ITEM: 6.1	COMMITTEE OF ADJUSTMENT REPORT SUMMARY MINOR VARIANCE APPLICATION FILE NUMBER A027/23 86 HAILSHAM COURT, WOODBRIDGE
------------------	--

**COMMITTEE OF ADJUSTMENT REPORT
MINOR VARIANCE APPLICATION
A027/23
86 HAILSHAM COURT, WOODBRIDGE**

ITEM NUMBER: 6.1	CITY WARD #: 3
APPLICANT:	Shamin Ali & Zhanna Prokopchuk
AGENT:	Square Design Group
PROPERTY:	86 Hailsham Court, Woodbridge
ZONING DESIGNATION:	See Below
VAUGHAN OFFICIAL PLAN (2010) DESIGNATION:	Vaughan Official Plan 2010 ('VOP 2010'): "Low-Rise Residential"
RELATED DEVELOPMENT APPLICATIONS:	None
PURPOSE OF APPLICATION:	Relief from the Zoning By-law is being requested to permit the construction of a proposed cabana, swimming pool and installation of related pool equipment and to permit reduced rear yard landscaping requirement.

1 SITE PLAN
A1 1:150

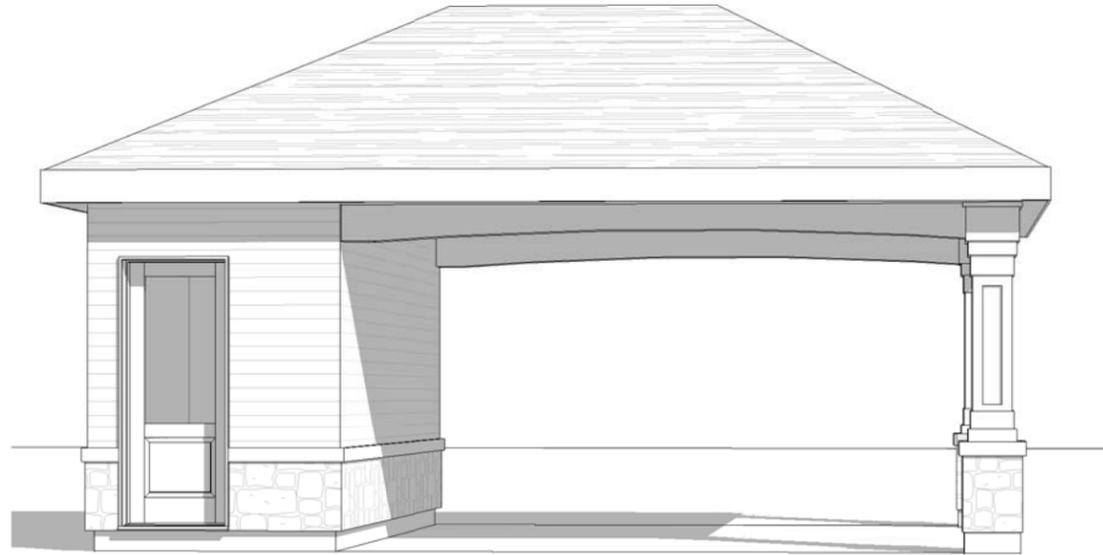
The proposed work by the Owner / Applicant is increasing the lot coverage on the subject property. The added hardscape may have impacts on the City's Storm Water management system. Development Engineering strongly encourages the Owner / Applicant introduce Low-Impact Development (LID) measures (e.g., bioswales, permeable pavers, rain gardens, rain barrels etc.) to reduce the impacts to the stormwater system. Should further information be required, please contact the Development Engineering COA reviewer.

The Owners have revised their application to provide additional rear yard soft landscaping upon recommendations from the Development Planning Department. The Development Planning Department has no objection to Variances 4 and 7 for the revised rear yard soft landscaping as the reduction in soft landscaping is minor in nature and will maintain an appropriate balance of soft landscaping to facilitate drainage, reduce urban heat island effects, and facilitate the establishment of vegetation. The Development Engineering Department has also reviewed the proposal and is satisfied that drainage in the rear yard will be maintained.

Development Planning Recommended Conditions of Approval:	That the final Landscape Plan be approved to the satisfaction of the Development Planning Department.
---	---
